NEW STYLE PART 1

This new style motor and snap ring assembly process eliminates the need for the aluminum plate and silicone.

NEW STYLE PART 2

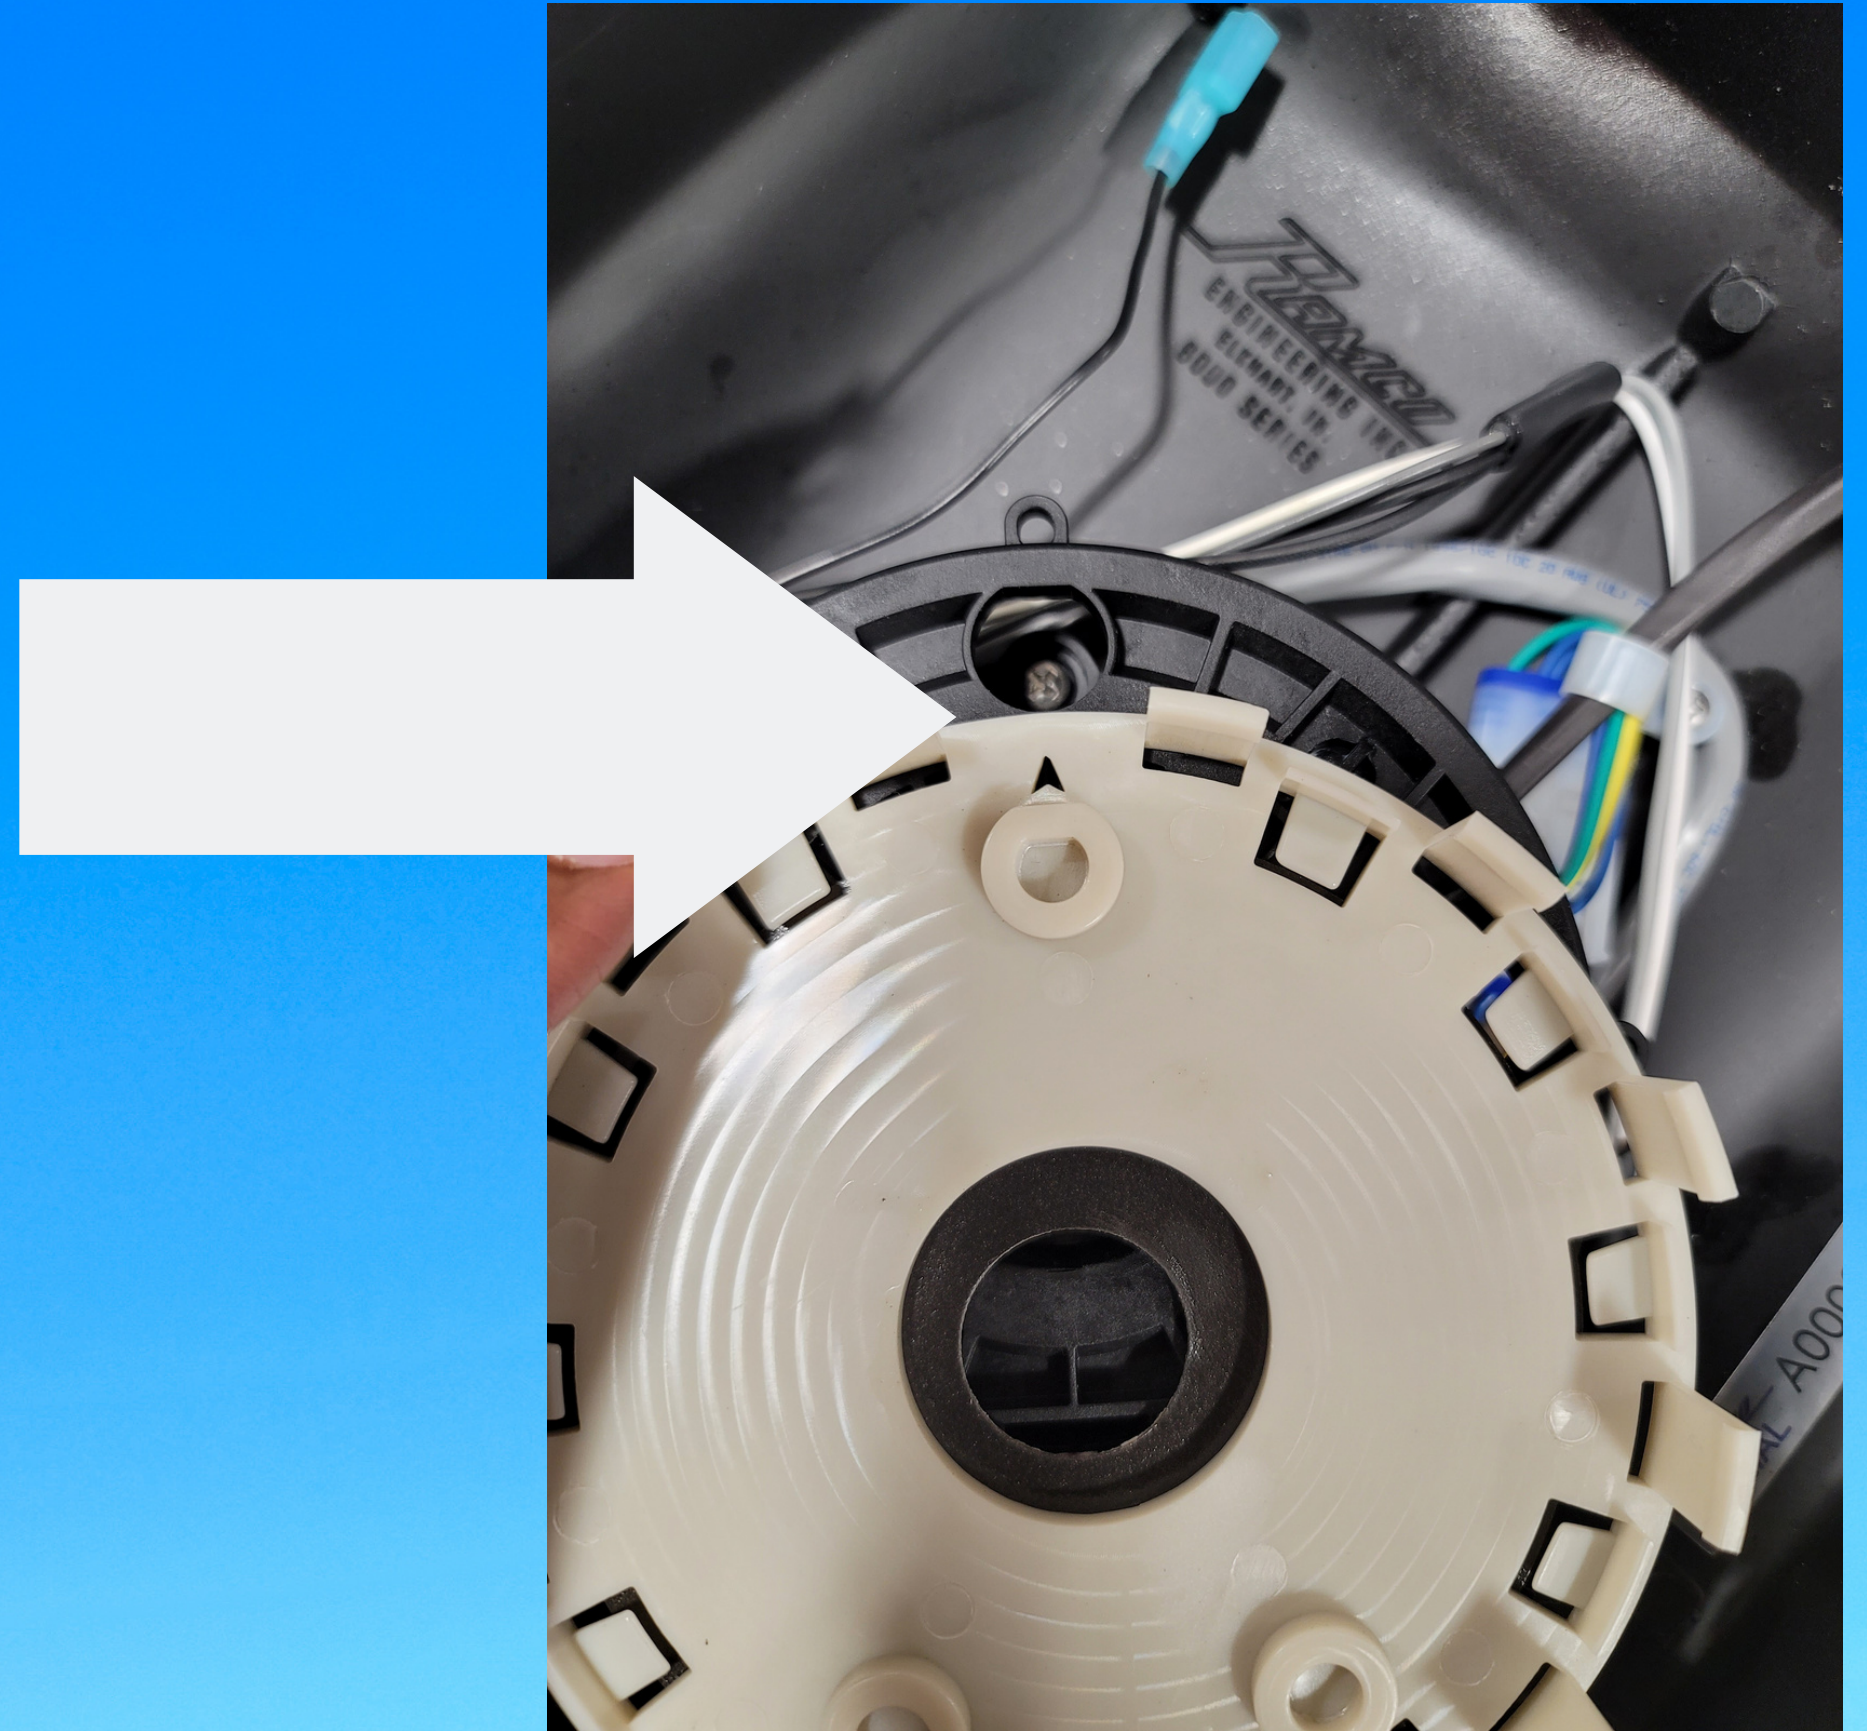
The snap ring is placed onto the rim of the motor until all clips are fully engaged.
